MILITARY SPECIFICATION

ALTIMETER SET, ELECTRONIC AN/APN-141(V)

This amendment forms a part of Military Specification MIL-A-23887A(WP) dated 1 December 1965 and has been approved by the Bureau of Naval Weapons, Department of the Navy.

Figure 3. Indicator ID-881B/APN-141(V)

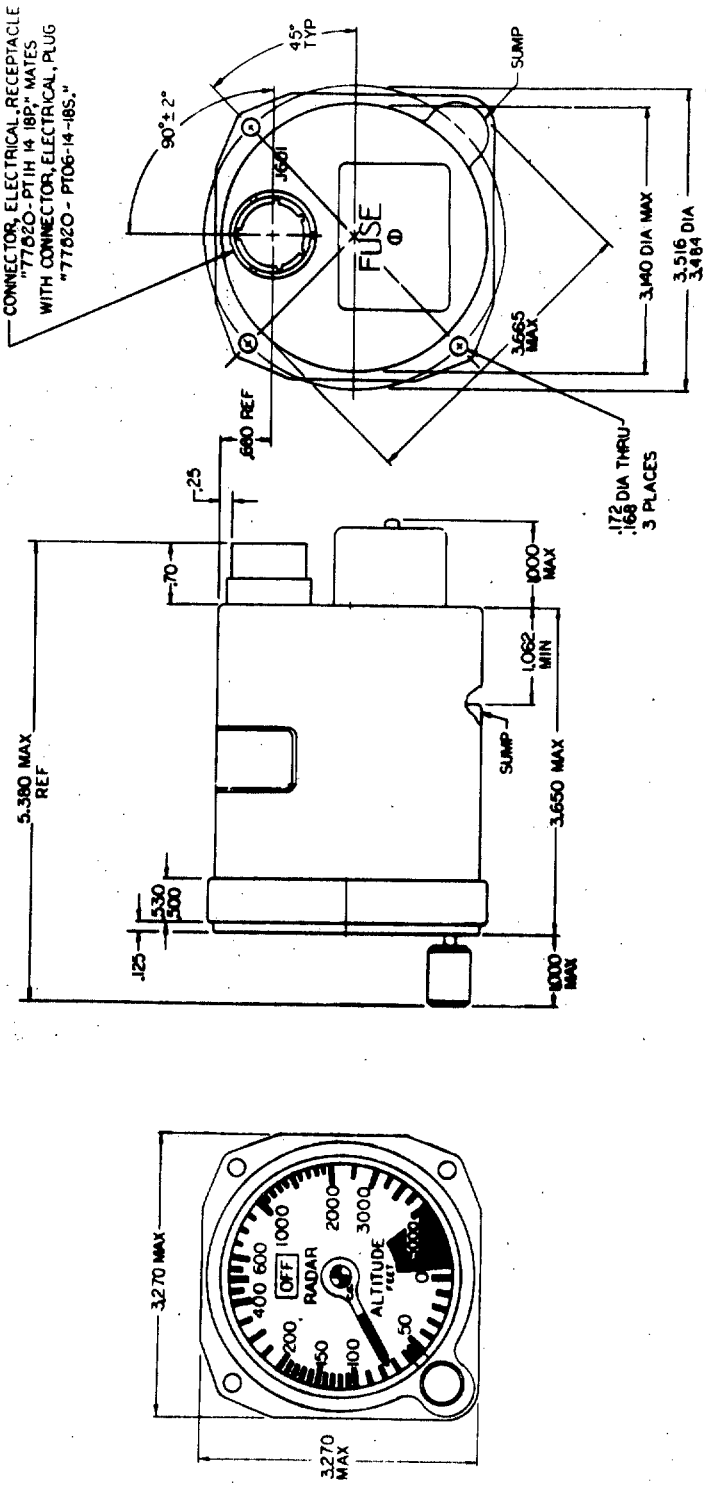
Page 22, Figure 3: Delete and substitute the new Figure 3. of this amendment.
